**SOUTHEAST ATLANTA LIBRARY
ADDENDUM #1
OCTOBER 8, 2014**

This Addendum #1 dated October 8, 2014 issued by C D Moody Construction, Co., Inc. is hereby made part of the Southeast Atlanta Library. The changes and/or clarifications included in this Addendum shall be considered as part of the Bidding Documents and shall supersede, amend, add to, or subtract from those conditions included in the original Bid Documents, including the Project Bid Package, Drawings, Specifications, previous Addenda, etc.

Addendum #1 Requests For Information

**NEW SOUTHEAST
ATLANTA PUBLIC LIBRARY**
1463 PRYOR ROAD SW
ATLANTA / FULTON COUNTY, GEORGIA 30315

DRAWING TITLE
FIRST FLOOR
AND FOUNDATION
PLAN

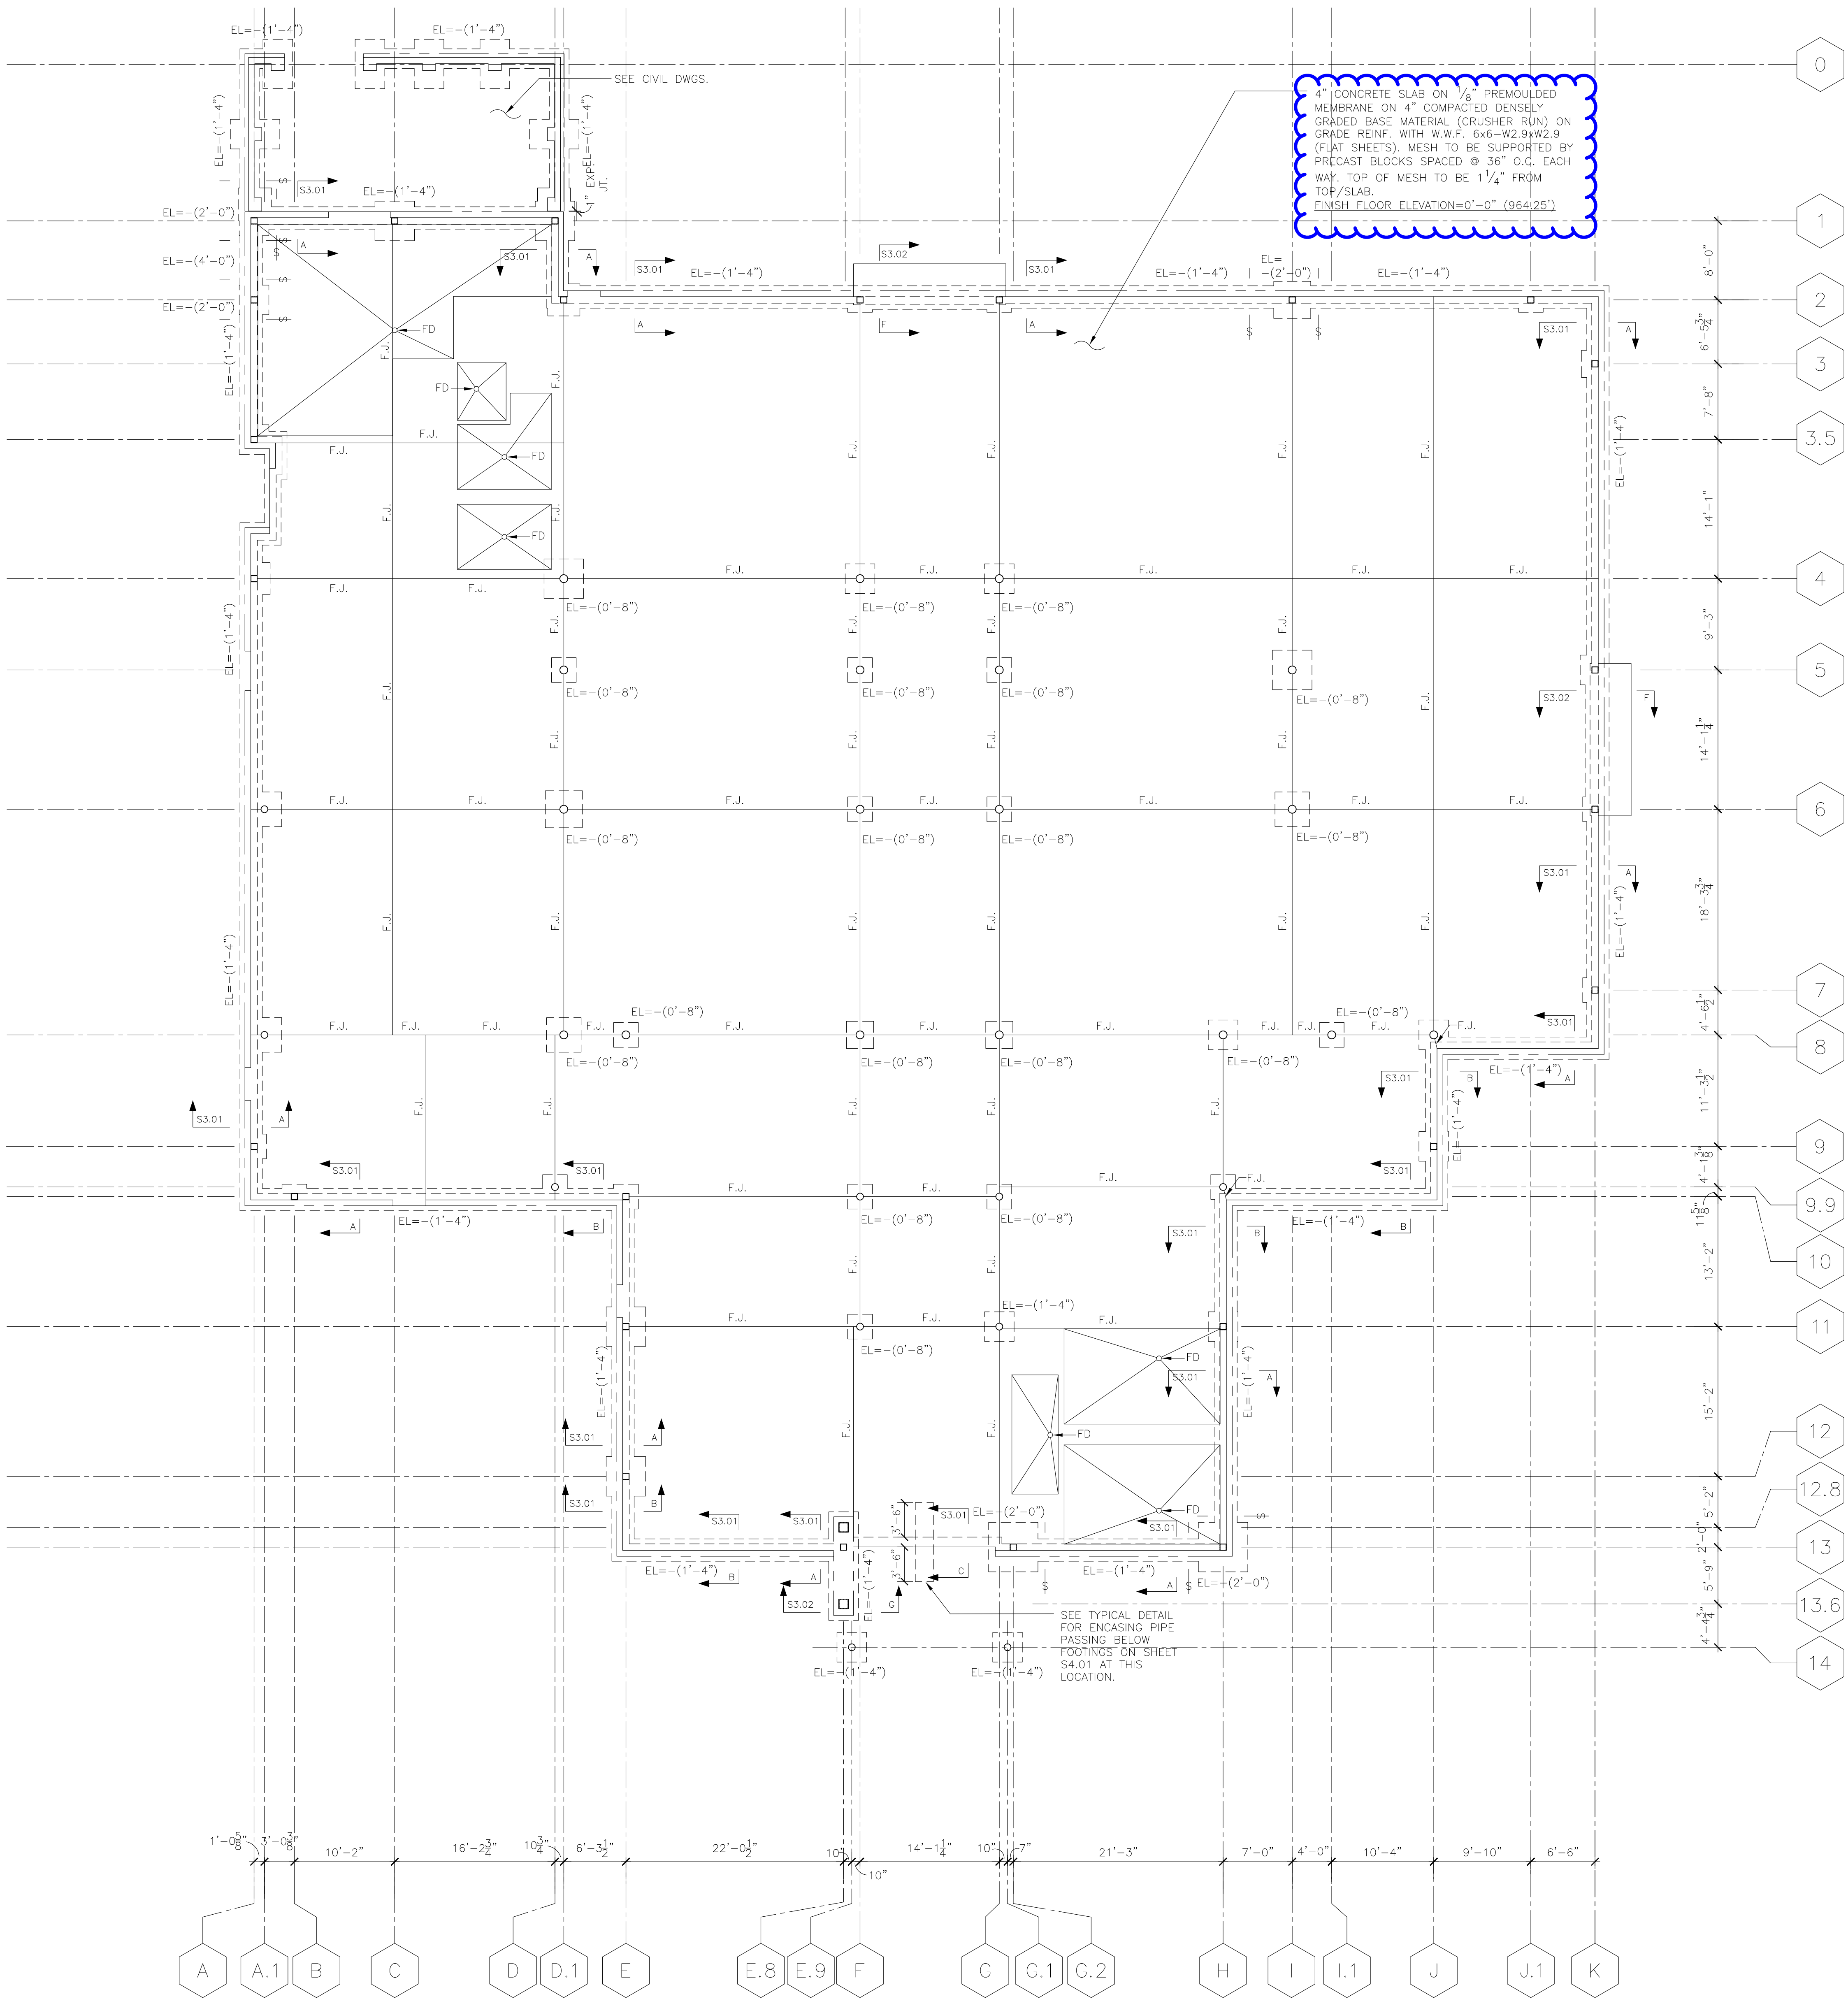
Structural sheet S1.01 notes that base material for slab should be a 4" layer of densely compacted base material (crusher run). The Passive Radon System Detail on M5.01 notes that the base layer directly beneath the slab should be a 4" layer of gas permeable material (clean aggregate or sand). This insinuates that the materials should not be fully compacted to allow for permeability. CDM has a concern that if base layer of material directly beneath the slab is not densely compacted as the Structural Drawings require, there will be Structural issues with the support of the concrete slab above resulting in cracking and possible structural failure of the slab. Please advise. See attached referenced documents.

REVISED BY S+R ON 9/16/14
Response We recommend providing a 4" thick uniform layer of clean
Response By coarse aggregate. This will not change the design of the slab.
Responded H. Jeffreys

DRAWING TITLE
SITE STAKING
& LAYOUT PLAN

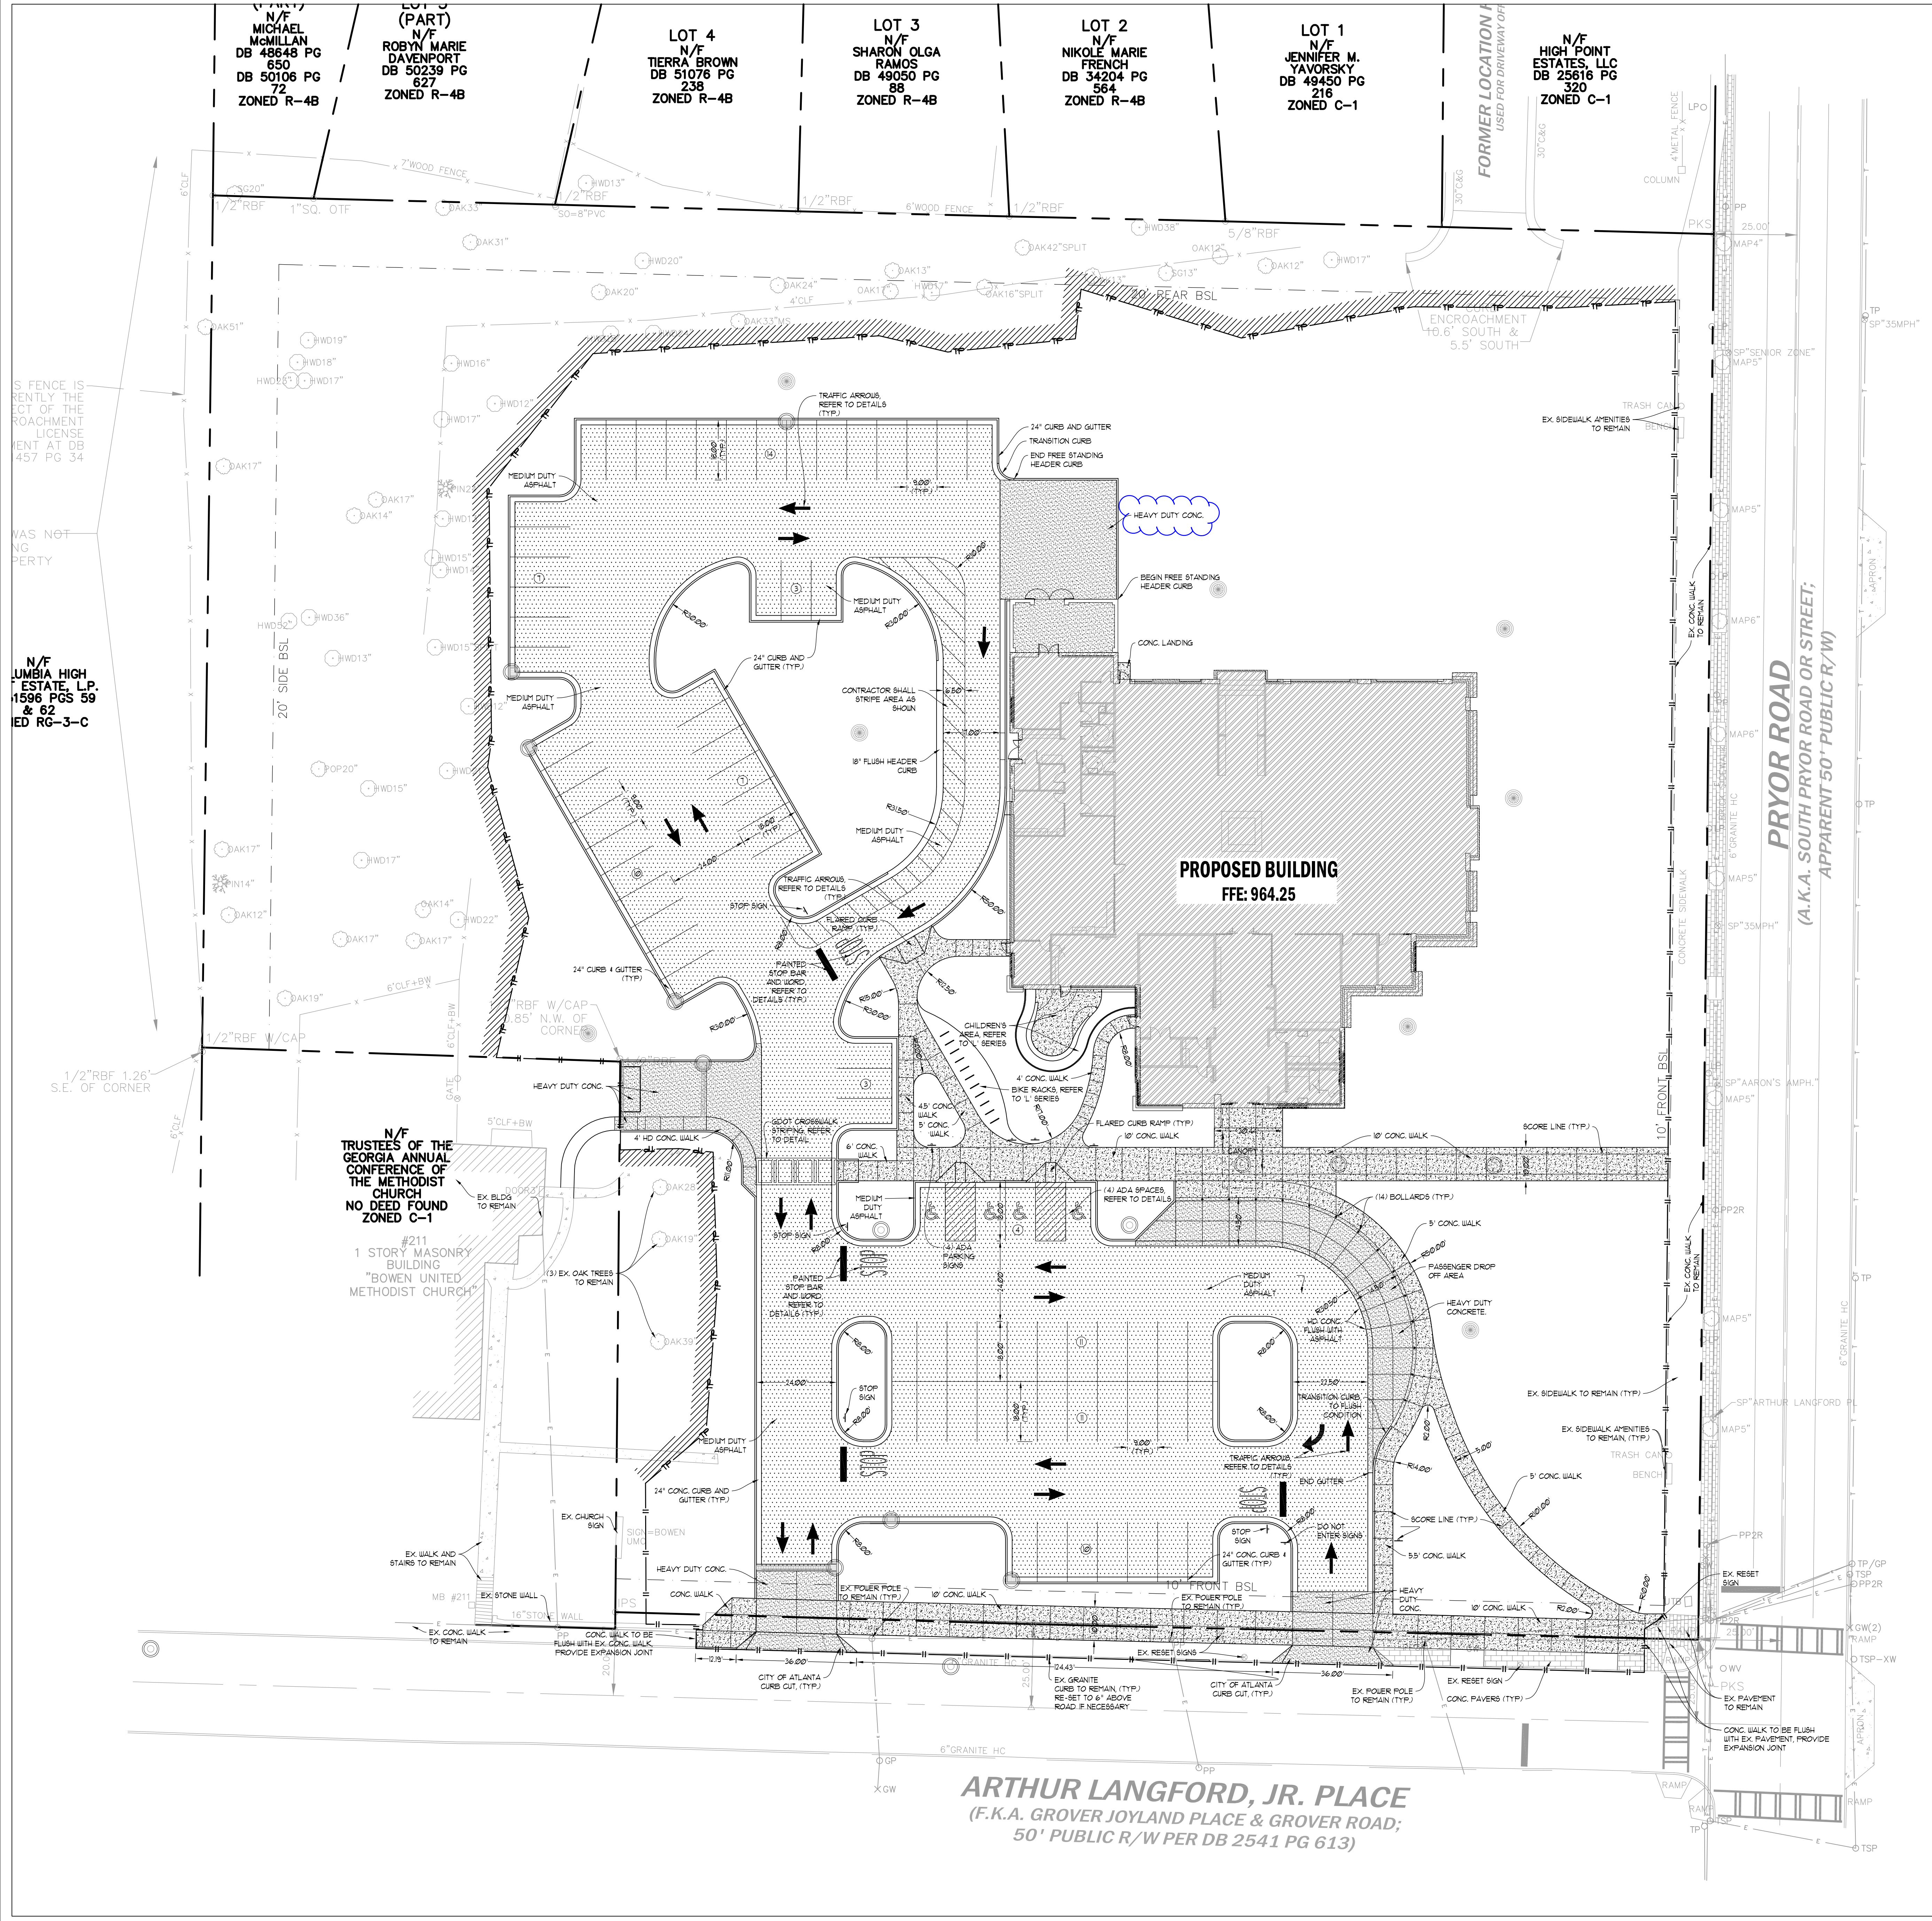
Sheet C2.00 notes that slab for mechnacal yard should be heavy duty pavement (Ref. Detail 3/C6.00). Finish schedule on A1.22 states that the mechanical yard should be gravel. Please confirm mechanical yard will recieve heavy duty pavement.

Response	Mech yard will be heavy duty concrete paving. Refer to C200, C300 and C600 for details.
Response By	Alan Wieczynski- Breedlove Land Planning
Responded	9.10.14
